Surface Water Review – Strada Pit & Quarry March 18, 2026

Melancthon, Ontario

1. INTRODUCTION – OVERVIEW OF RETAINER AND SCOPE

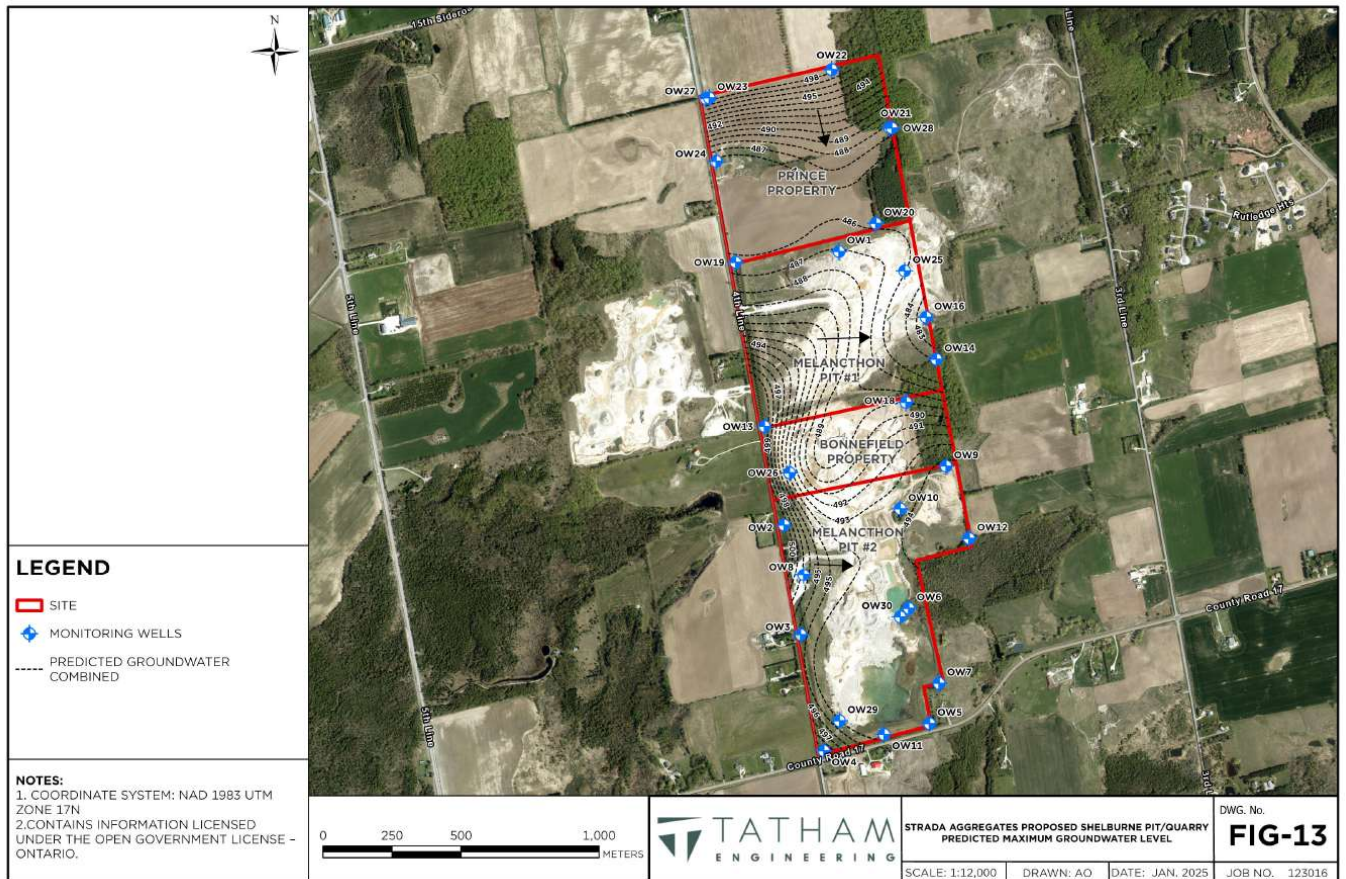
- NRSI determined that there are three areas of Site Plan encroachment beyond the existing pit limit of extraction including:
 - a portion of the central infiltration pond,

- a portion of the proposed created wetland, and

- a small northern extension of a proposed berm along the east side of the south infiltration pond
- **Direct Impacts:** Proposed quarry operation will require the removal of the four small wetland features on the Melancthon Pit #2 site to accommodate the central infiltration pond
